Access Compliance Report
Public Rights-of-Way
(Curb Ramps)

Intersection ID: N/A	Main Street: CRAIGWOOD_DR	Cross Street: HICKORY_GROVE_RD	Location:	SW
ADA ID: FEE901B1113E	Ramp Type: Combination2Diag	Initial Pass/Fail: Fail	Overall Compliance: No	Severity Score: 0

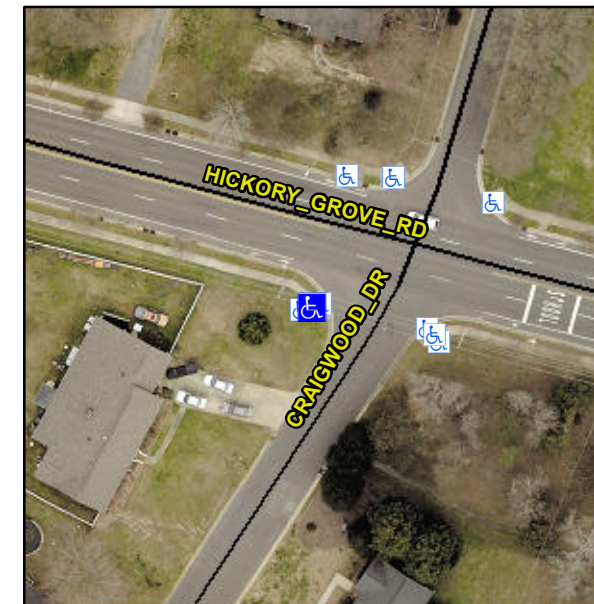
Not Found, R304.5.3, R304.3.2

Compliance	Description	Data	Compliance	Description	Data
N/A	Ramp Length LT (in)	49.0	N/A	Ramp Length RT (in)	36.0
Yes	Ramp Width LT (in)	59.5	Yes	Ramp Width RT (in)	60.0
Yes	Ramp Slope LT (%)	2.9	No	Ramp Slope RT (%)	8.9
Yes	Ramp XSlope LT (%)	1.2	Yes	Ramp XSlope RT (%)	1.6
N/A	Ramp Length (in)	48.0	Yes	Ramp Slope (%)	7.2
Yes	Ramp Width (in)	48.0	No	Ramp XSlope (%)	2.8
N/A	Flare Type LT	N/A	N/A	Flare Type RT	N/A
N/A	Flare Slope LT (%)	N/A	N/A	Flare Slope RT (%)	N/A
N/A	Flare Traversable LT?	N/A	N/A	Flare Traversable RT?	N/A
N/A	Landing Length (in)	N/A	N/A	DWS Provided?	N/A
N/A	Landing Width (in)	N/A	N/A	DWS Contrast?	N/A
N/A	Landing Slope (%)	N/A	N/A	DWS Length (in)	N/A
N/A	Landing X Slope (%)	N/A	N/A	DWS Full Width?	N/A
N/A	Landing Curb? (Y/N)	N/A	N/A	DWS Offset (in)	N/A
N/A	Shared Landing?	N/A			
N/A	Gutter Ponding?	N/A	N/A	Gutter Slope (%)	N/A
N/A	Gutter Lip Ht (in)	N/A	N/A	Gutter X Slope (%)	N/A
N/A	Painted X Walk1?	No	N/A	Painted X Walk2?	No

Remove & Replace Curb Ramp With Two New Directional Ramps or Equivalent.
